# UNITED STATES PATENT AND TRADEMARK OFFICE

APPLICATION NO.	FILING DATE	FIRST NAMED INVENTOR	ATTORNEY DOCKET NO.	CONFIRMATION NO.
10/009,696	11/06/2001	John Eric Arnold	DN1999111USA	1392

<b>Office Action Summary</b>	<b>Application No.</b> 10/009,696	<b>Applicant(s)</b> ARNOLD ET AL.	
	<b>Examiner</b> Lan Nguyen	<b>Art Unit</b> 3683

## DETAILED ACTION

FIG.4

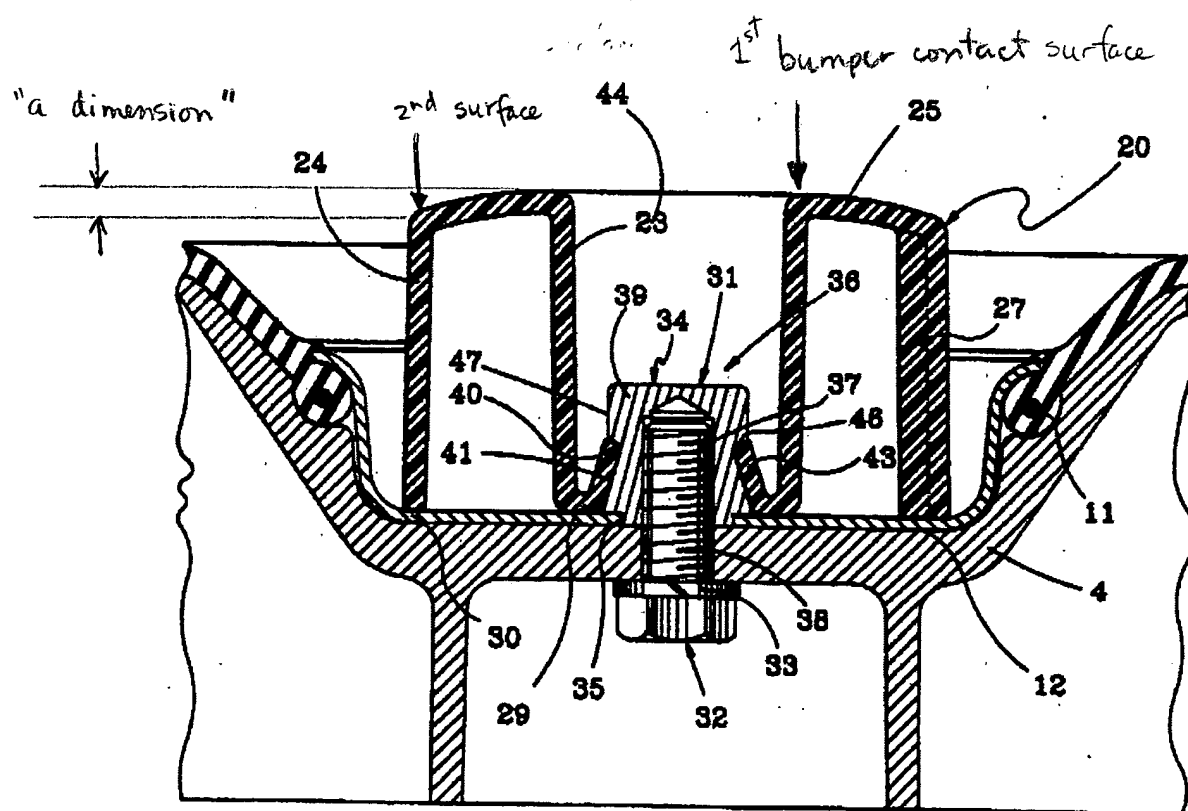
and at the opposing end to other retainer as shown, the improvement being characterized by: one of the retainers 12, 20 having a bumper-contact surface, please see the marked up figure below, within the sleeve 10 for axial movement into the sleeve, the bumper-contact surface formed as a part of the retainer 12, 20 and which contacts the other retainer when the air spring is collapsed, and absorbs and transmits forces generated from such contact, the bumper contact surface being centrally located on the surface of the retainer which extends into the sleeve during axial movement into the sleeve.

Re: claim 5, Ecktmann shows the first contact surface to be closer to the center corresponds to rib 29, the second contact surface to be further out corresponds to rib 30 and are separated by a dimension, please see the marked up figure above.

Re: claim 18, Ecktman shows the retainer 12, 20 extends into the chamber 15 and the axially outer surface to be closer to the center corresponds to rib 29, a separate axially outer surface to be further out corresponds to rib 30 and are separated by a dimension, see marked up figure above.
